Project
St. Charles Church Addition

Engineering Review Response

Re: Village of Hartland
St. Charles Church Addition
DRAFT Plan Review Letter

The Village of Hartland's Staff as well as Ruekert & Mielke, Inc. (R/M) have reviewed your site plans submittal dated December 6, 2019 consisting of 25 plan sheets. In addition, a storm water management plan was prepared by Harwood Engineering Consultants, Ltd. dated December 30, 2019. We are providing the following comments as guidance and direction for your design staff in preparation of your next plan submittal. **Please respond to the comments below, in writing, with your next submittal.** You should plan to attend the Plan Commission meeting on **January 20, 20 at 6:00 pm** to present your project plans.

Sheet:
SITE PLAN -
DETAILED EAST

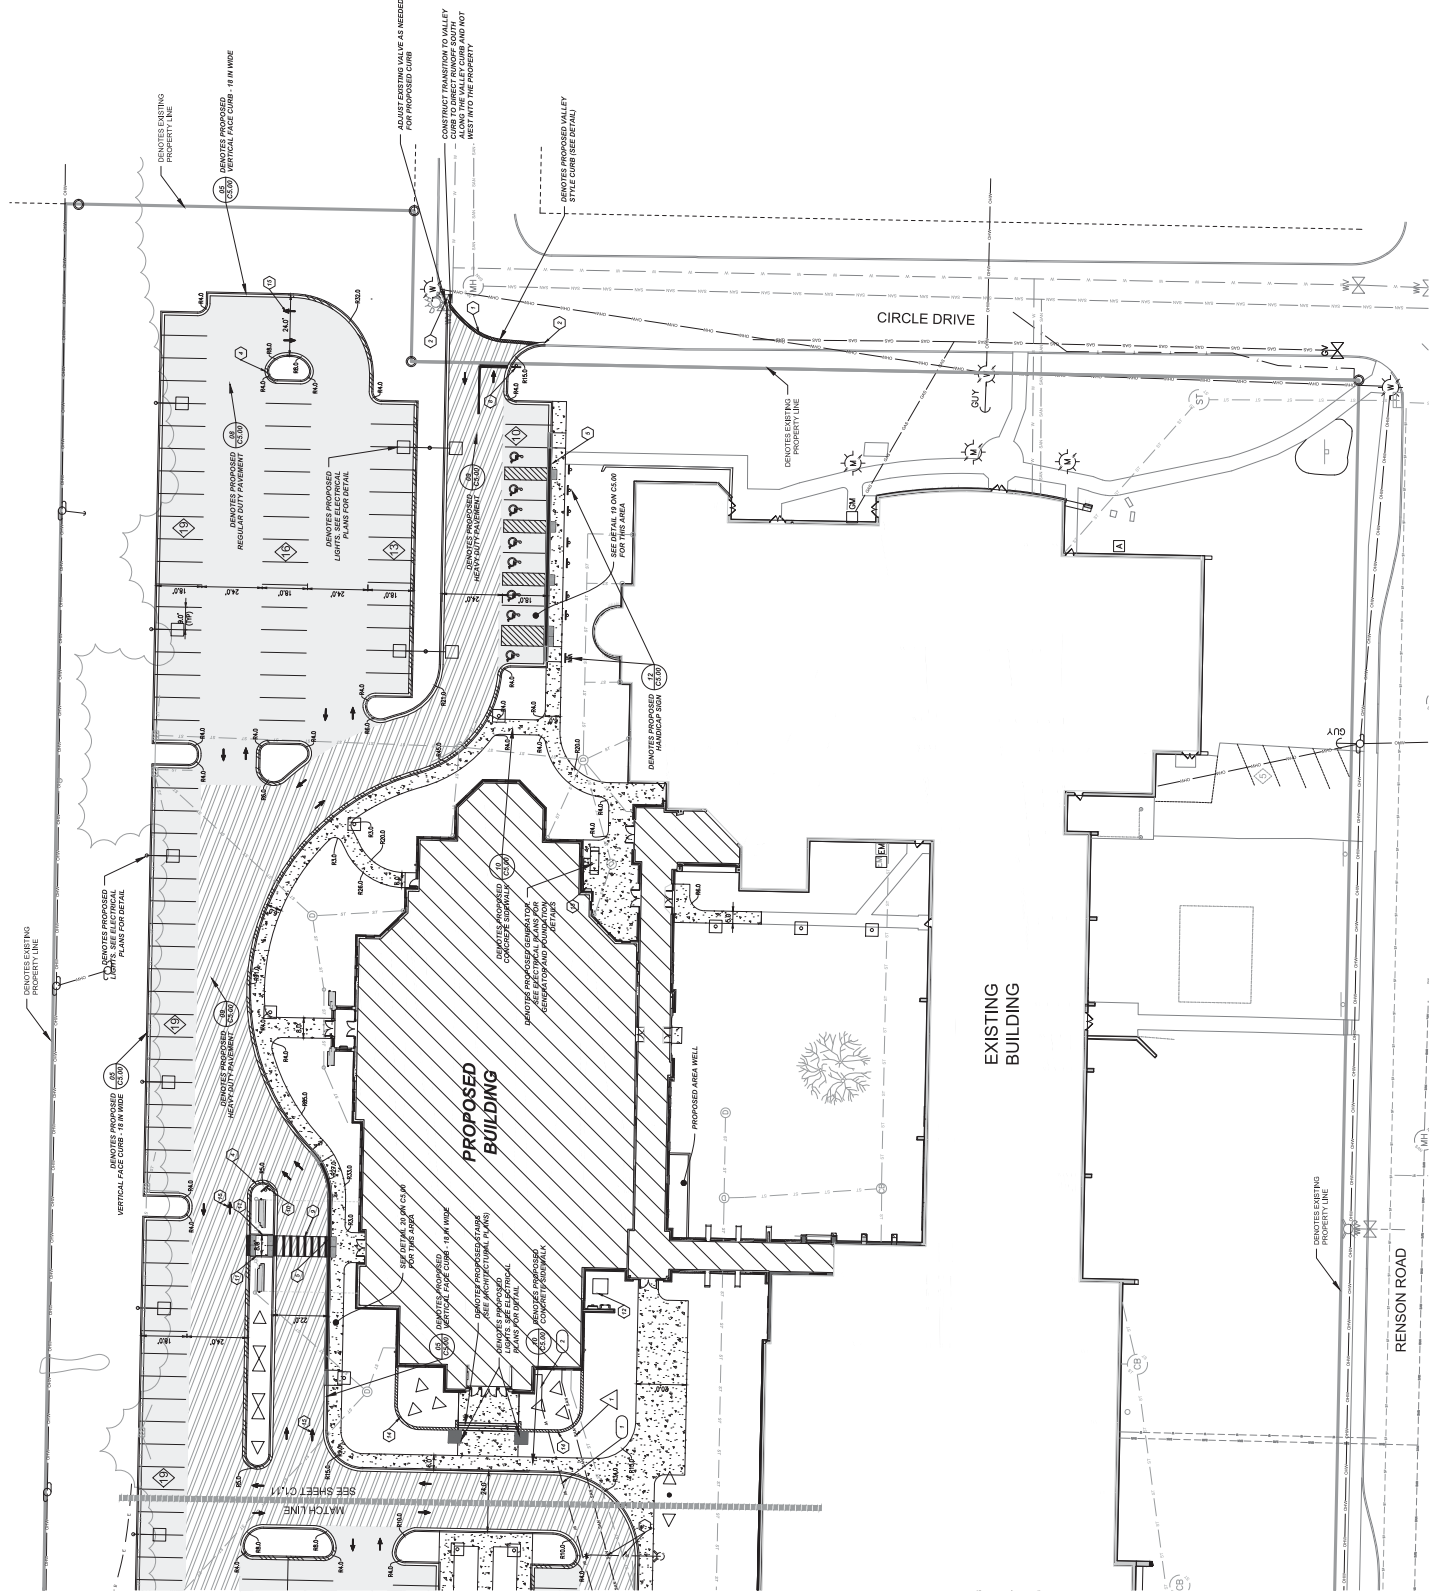
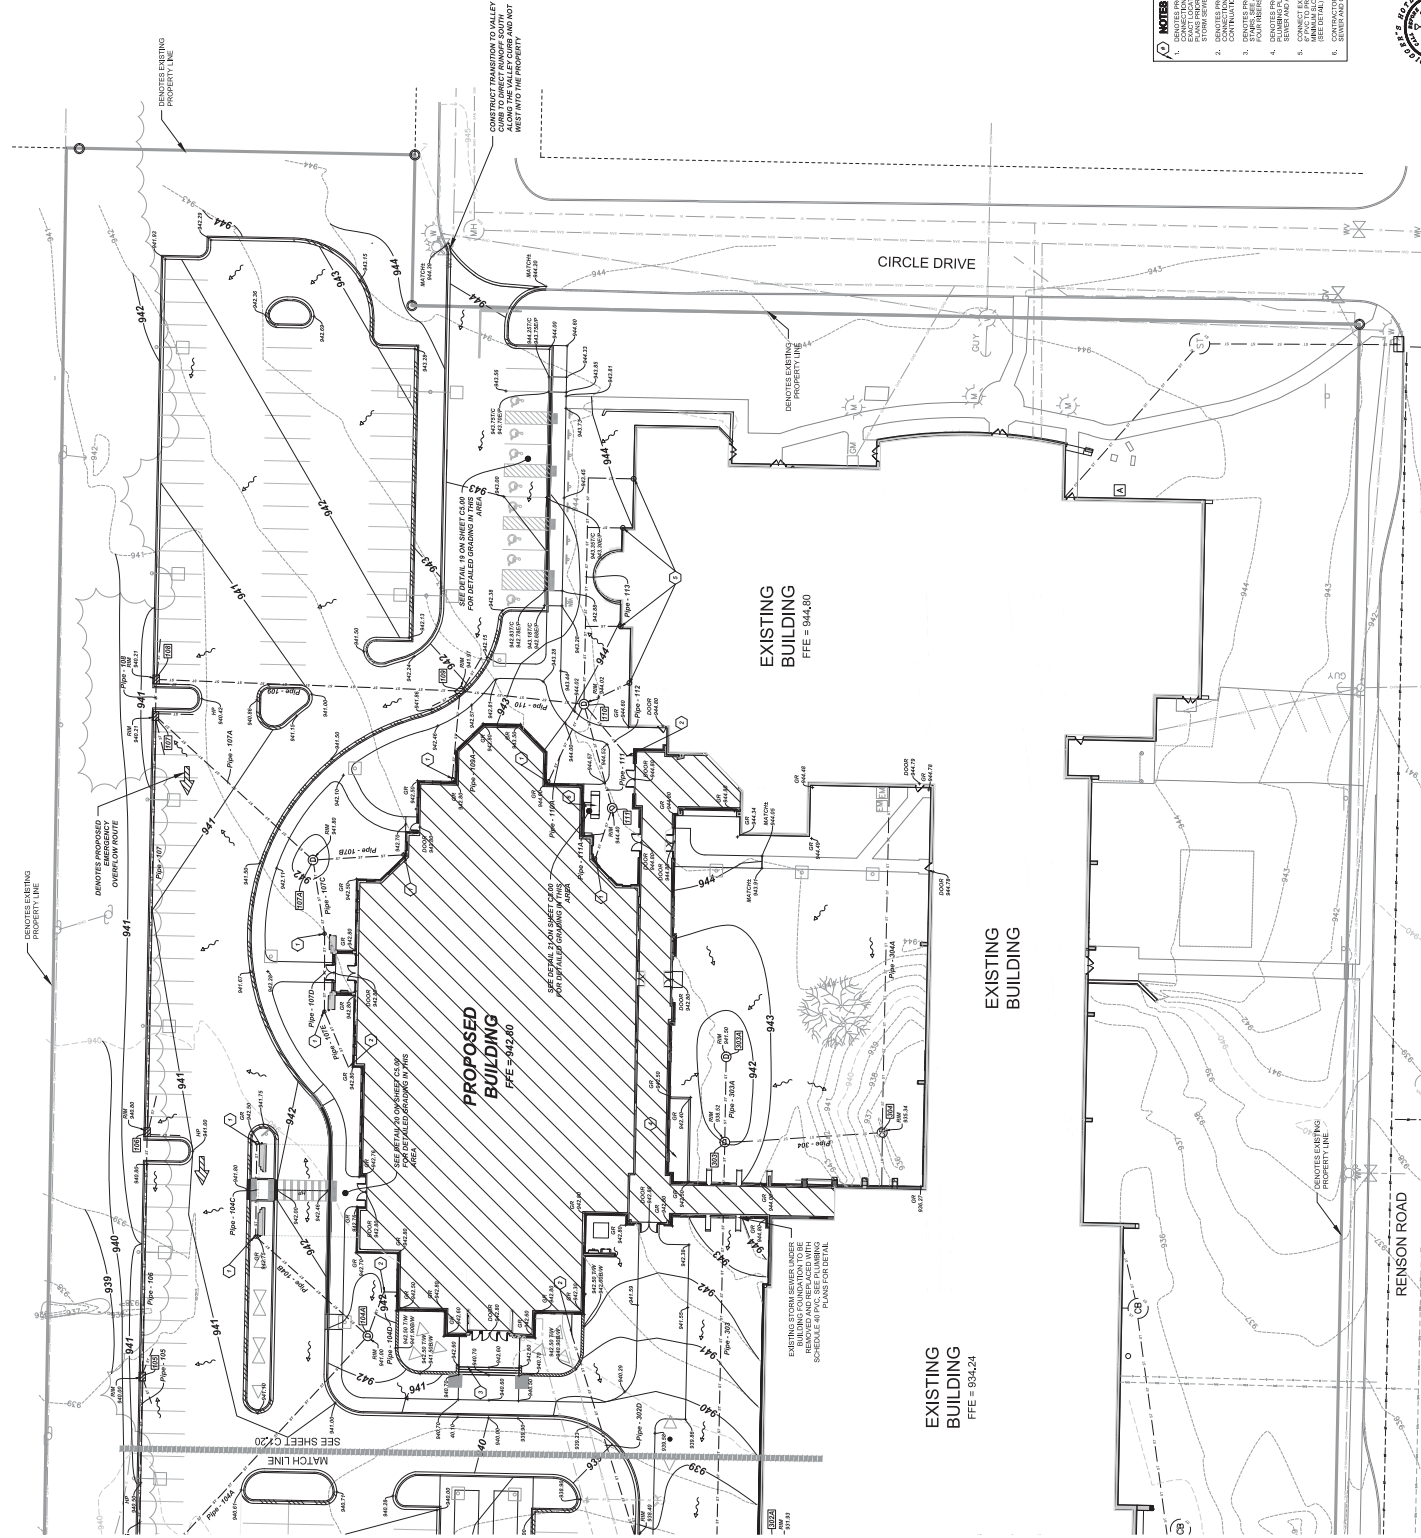
Site Plan – Detailed West/East - Sheet C1.11/C1.12

- 8. The westerly access drive was discussed at a previous Plan Commission meeting as being a one-way egress drive with a 16-foot width. The current plan shows a two-way 24-foot wide ingress/egress drive.
 - a. If the 24-foot wide ingress/egress drive is used, then a three-way, stop-controlled intersection is suggested, with an additional cross walk located to align with the south Renson Road sidewalk.
 - b. If the 16-foot wide egress drive is used, then the egress drive would have a stop sign where it connects to Renson Road.
 - c. The 16-foot wide egress drive allows for an additional 8-feet of separate between the access drive and the westerly property line for buffering.

- d. The area between the access drive and westerly property line should be reviewed to determine if further vegetative buffer is necessary.
9. The sanitary sewer, water main, storm sewer and associated manhole/inlet/fire hydrant/valve structures within Renson Road and Circle Drive are shown incorrectly. The base mapping utilized on the 12/6/19 site plans appears to be from a number of years ago. The watermain was reconstructed in Renson Road and Circle Drive. The horizontal and vertical locations of the sanitary sewer, water main and storm sewer need to be field surveyed because each of the three utilities will be tied into. The Applicant is aware of this and is in the process of surveying the actual locations.

11. The existing access along Renson Road to the St. Charles Church School is gated during school hours. What will the plan be for gating or security for the proposed westerly access drive?

13. The proposed sewer and water connections in Renson Road require a plan/profile sheet showing the locations of the storm sewer/water main/sanitary sewer crossings in profile view. Insulation should be provided between storm sewer and water main anywhere in the road or on the site. The base mapping and connection locations should be revised based upon the updated field survey. Sizes of existing utilities should be shown.

14. The Site Calculation Table needs to identify the "Existing Regular and Handicap Parking Stalls".
15. The 18-foot by 9-foot parking stalls is a deviation from the 180 square feet minimum parking stall. This needs to be pointed out to the Plan Commission for consideration.

18. Expansion of northeasterly parking lot appears to be have significant impact on neighboring house. Show existing house, landscaping features and identify what the impact will be of this expanded parking lot on the neighbor.

Site Plan – Detailed West/East – Sheet C1.11/C1.12:

8. Driveway has been reduced to 16' width egress only with gates on each end.
9. Surveyor is working on existing utility info and the plan will be revised when received.
10. As discussed in our meeting design and construction of public control structure shall be by the Village.
11. Gates have added to the plan for the west access drive.
12. Drive has been reduced to 16' as discussed. *Will this be signed as No parking?*
13. Please clarify the need for plan and profile drawings of private utilities. This would be the first-time plan and profile drawings of private utilities has been required. Is this required by Village code? *Show Separation, Insulation, Utilities Properly Surveyed*
14. Existing parking counts have been added to the table. *Review them*

- Concurrence from Jean Cannon*
- ✓ 15. Parking stall size was discussed in detail at the concept level plan commission meeting. The plan commission had no issues with the parking stall size at that time.
 - ✓ 16. As discussed in our meeting we did not include ADA ramps here because of the stairs.
 - ✓ 17. Curb is not being proposed any closer to the hydrant than the current condition. Based on the survey the hydrant and valve will be located behind the curb matching the current configuration.
 - ✓ 18. The 7 parking spaces facing east have been removed from the plans. Note the landscape plan currently has an evergreen tree buffer proposed along that property line to screen the views of the parking lot.

DATE	01.15.20
PROJECT NO.	19-0081.HI
SHEET NO.	C1.30

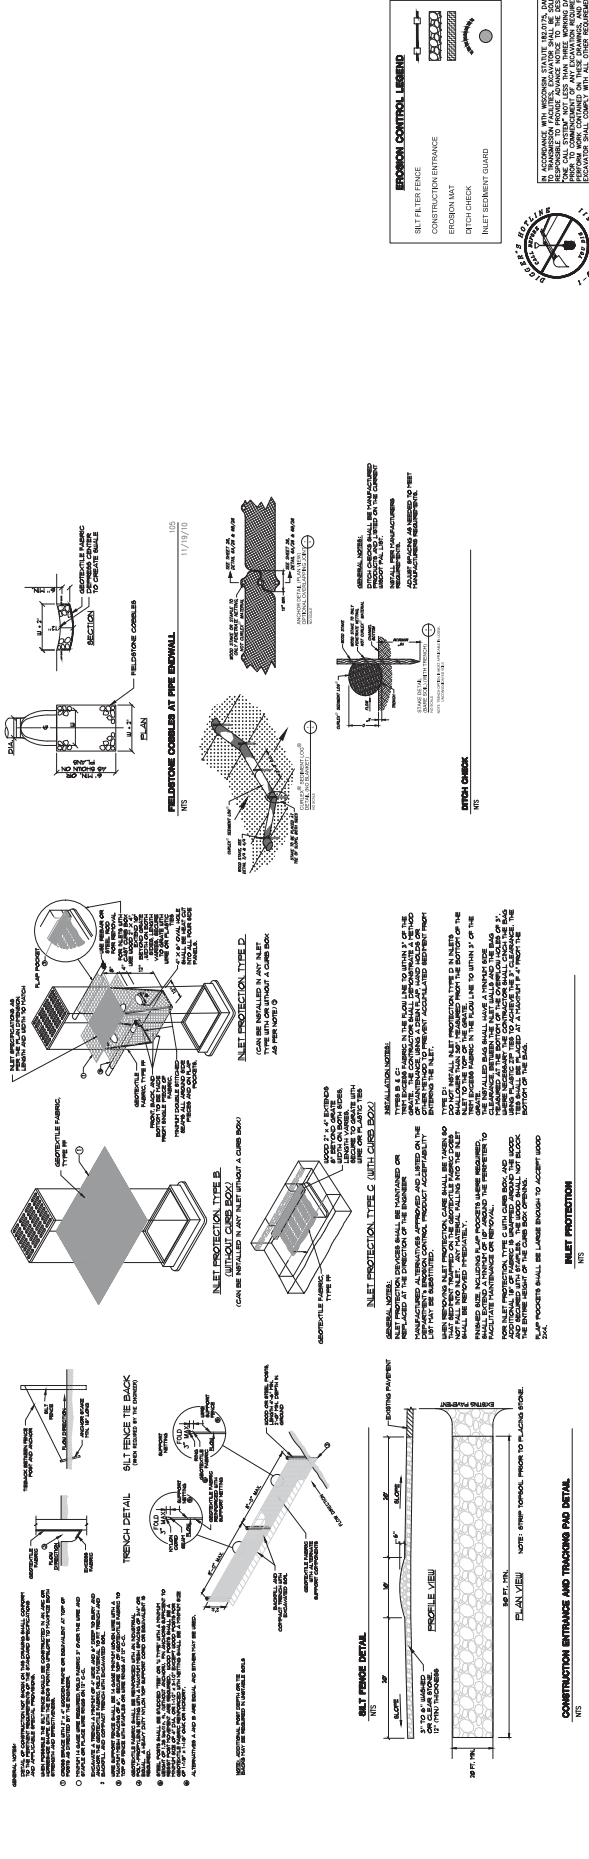
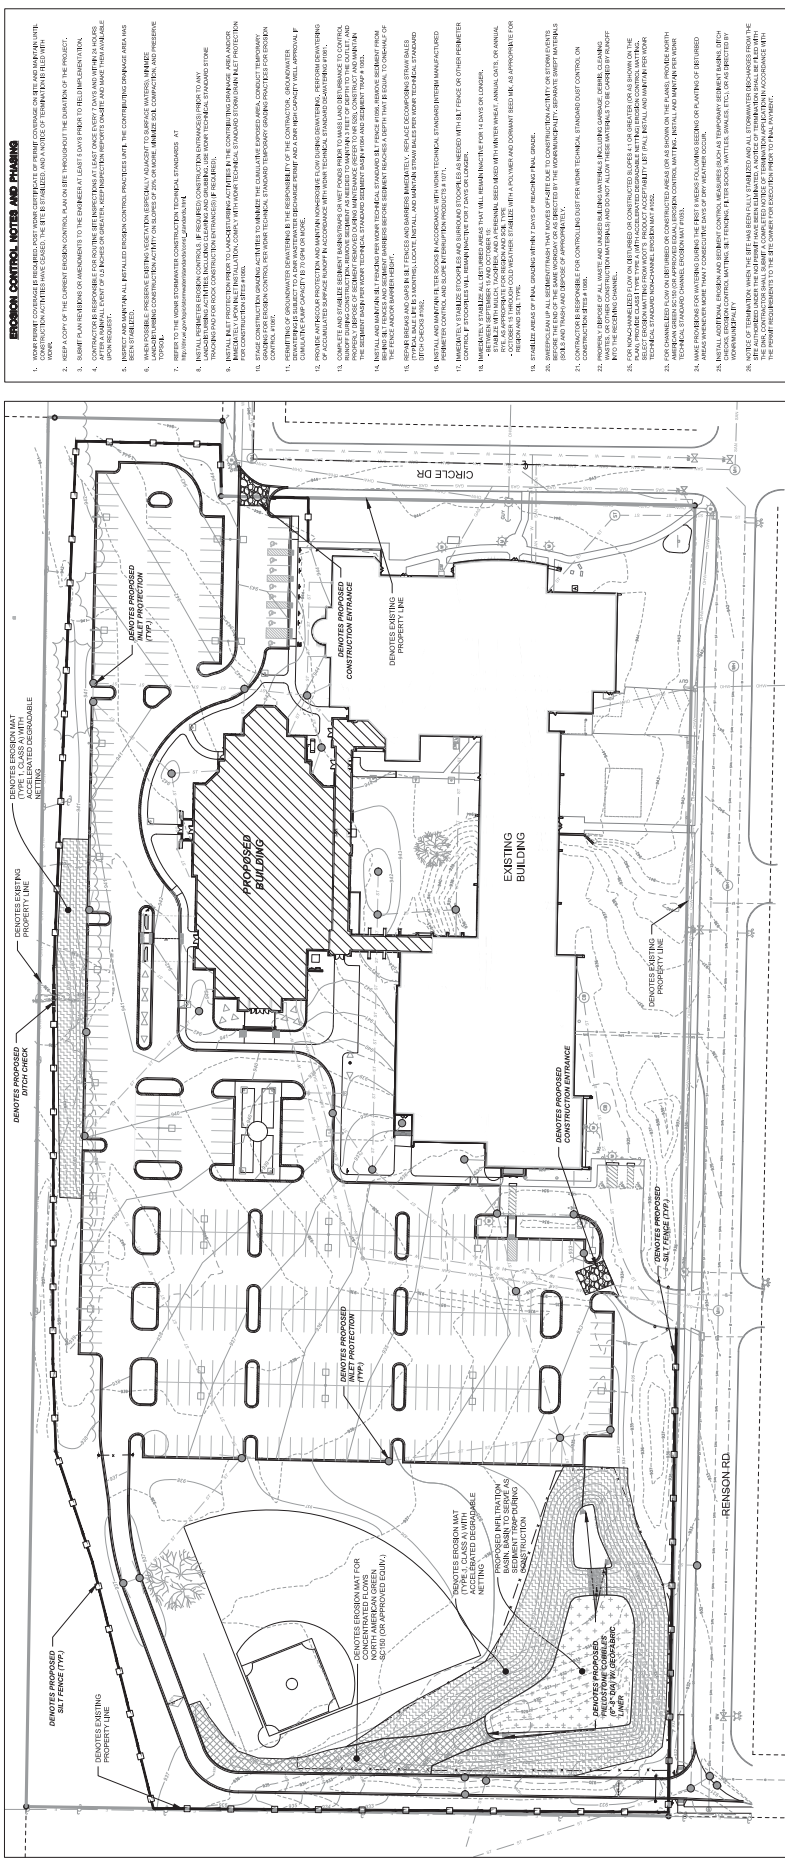
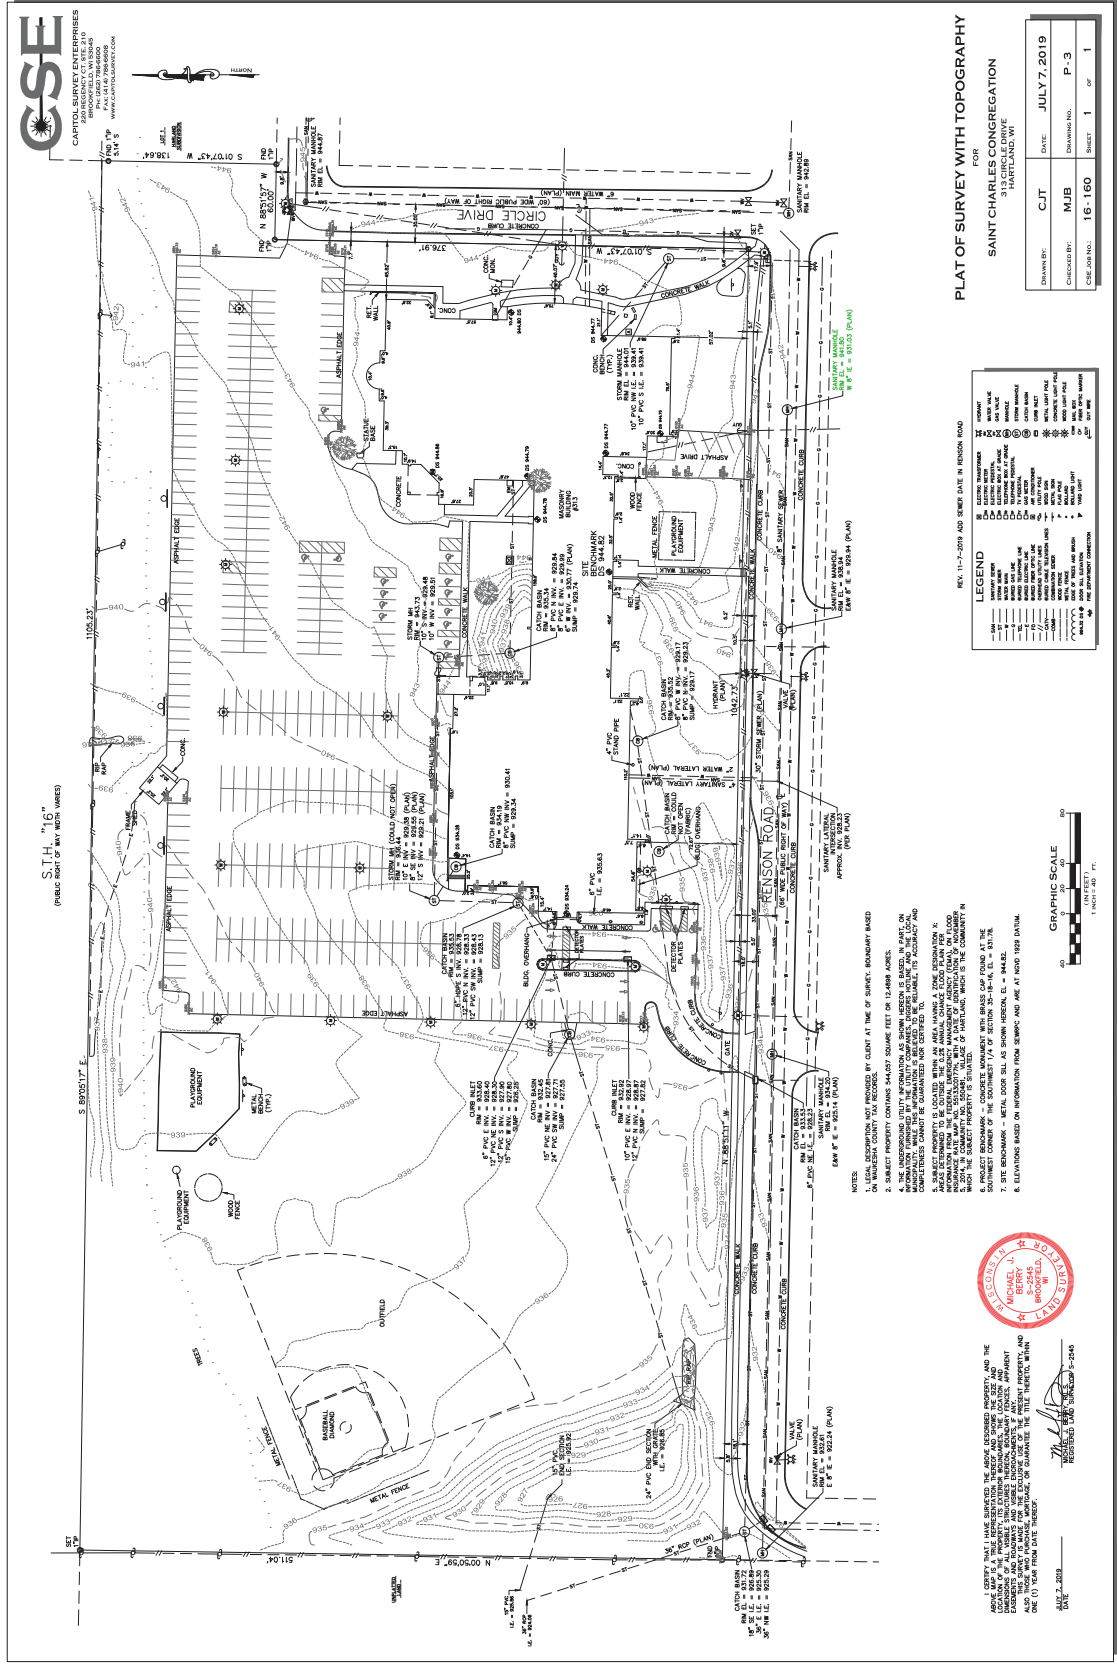
Erosion Control Plan - Sheet C1.30

24. Erosion Control Notes and Phasing – more specific details need to be provided regarding construction staging:
- a. Analysis of parking needed/available during construction, should influence which areas the contractor can disturb, and which areas of existing/new parking lots need to be available.
 - b. Show staging area on plan.
 - c. Are there any areas within the site needed for topsoil or excess material storage or is excess material being hauled away as it is excavated?
 - d. The connection of the Village's 36-inch storm sewer to the storm water basin, should be the last step after all other site improvements are completed and stabilized.
 - e. Construction traffic shall be restricted to utilize Circle Drive southerly to Renson Road and Renson Road easterly to Merton Avenue.

25. The plan shall require two preconstruction meetings:

- a. Administrative related preconstruction meeting 1 month in advance. Introduces all parties, sets expectations, allows for public notices.
- b. Field related preconstruction meeting 2 weeks in advance of construction. Introduces construction foreman, reviews plan and specifications, etc.

Erosion Control Plan – Sheet C1.30:

- 24. Construction staging and phasing is really a contractor means and methods item. Once a contractor is selected the contractor will work with the Village to prepare a staging and phasing plan for Village review.
- 25. So noted
